STATE OF OHIO
DEPARTMENT OF HIGHWAYS

S. H. 125 Sec. Decatur

TRAFFIC SIGNAL INSPECTION REPORT

SIGNAL NO 1904 LOCATION SR 125 - Co. Rds 14 & 22
DATE OF INSTALLATION 1-20-62 DATE OF INSPECTION 9-12-69
COUNTY BROWN DIVISION 9

S6# 1904 S.E. 12.5 - Co RDS 14 - 22. TREAWN CO. DIV
WEST APPR. DR 12.5

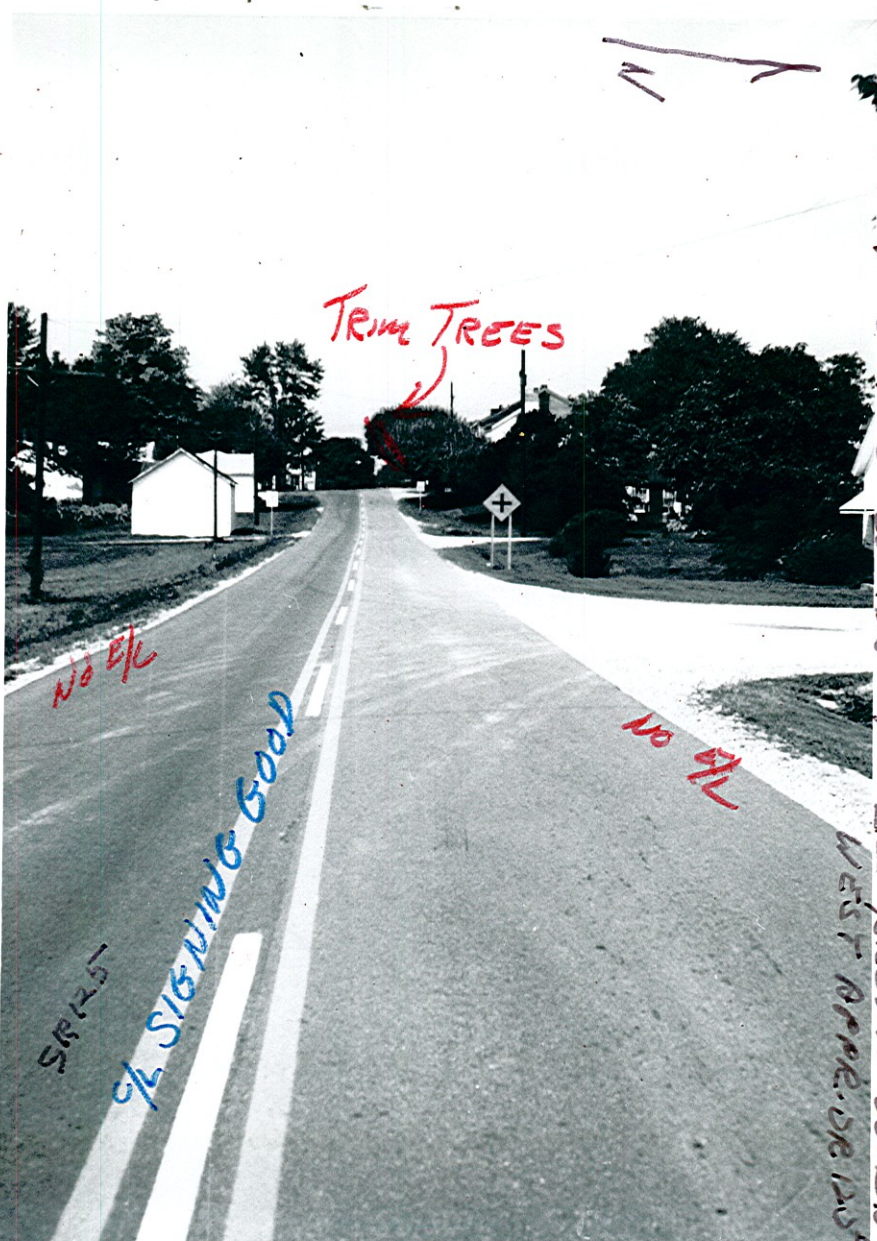
- ① Trim Trees as per photos 1-3
- ② Have TWP. or County put down
S/Bs E/L and E/L on TYP RDS 14-22
- ③ Paint Conduits and Fittings.
- ④ Div. 9 paint E/L on SR 125.
- ⑤ Replace Jack Mounted Flasher,
F.P.M. only 36.

TRIM TREES

Sta. # 1904 SR 125 - Co. ROS 14-22 BROWN CO. DIV. 9

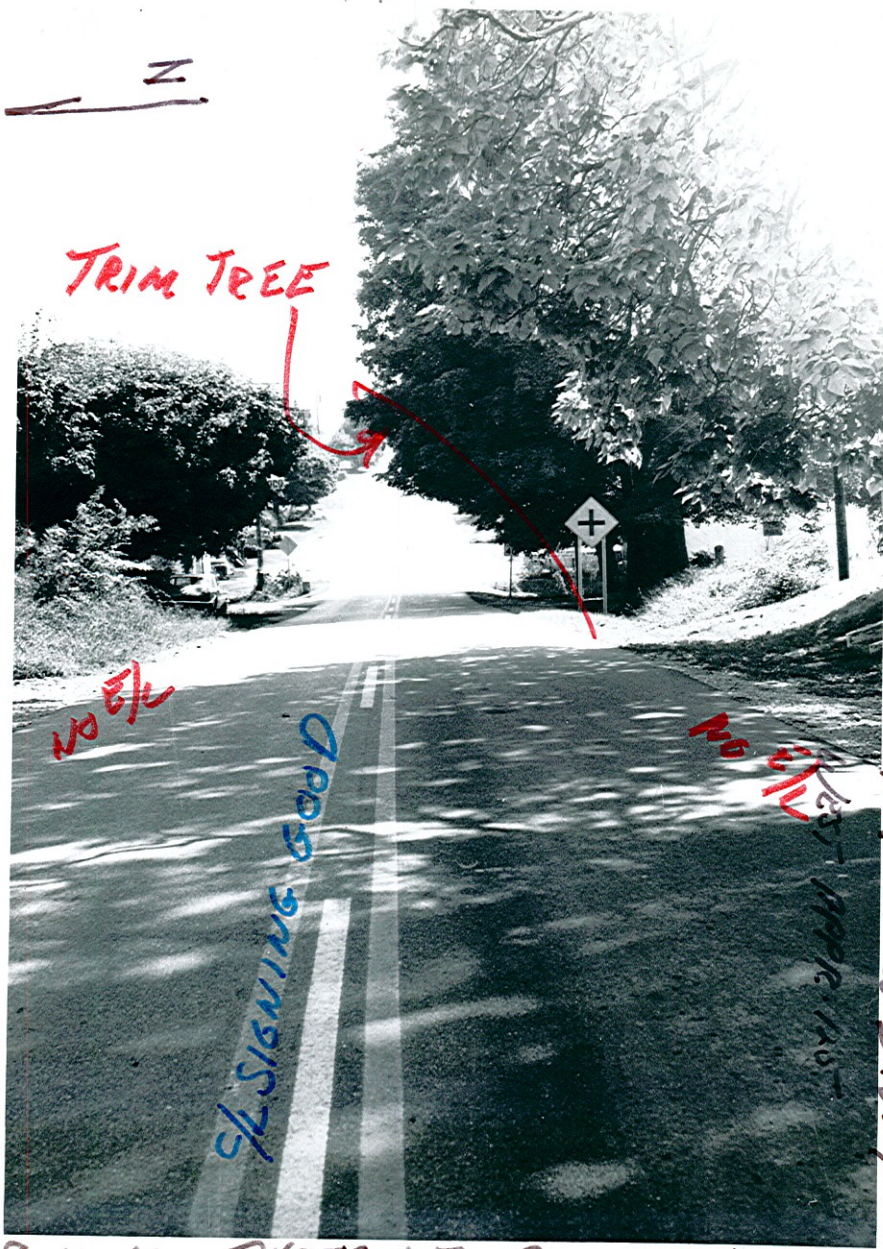
TRIM TREE

SIC # 1904 SE 125 - Co. Pos. 04-22 BERN CO. DIV. 9

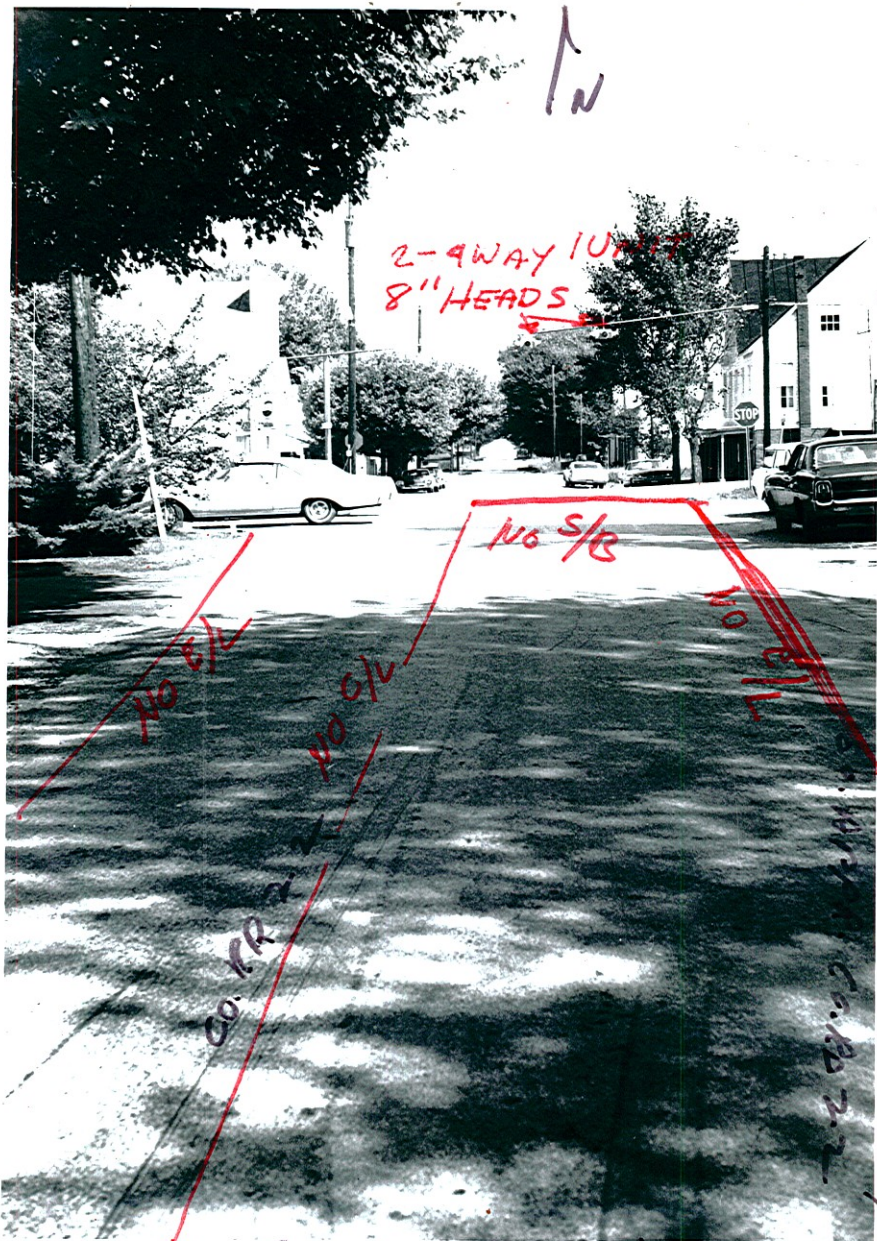
NO S/B

JACK MOUNTED
FLASHER

NO S/B
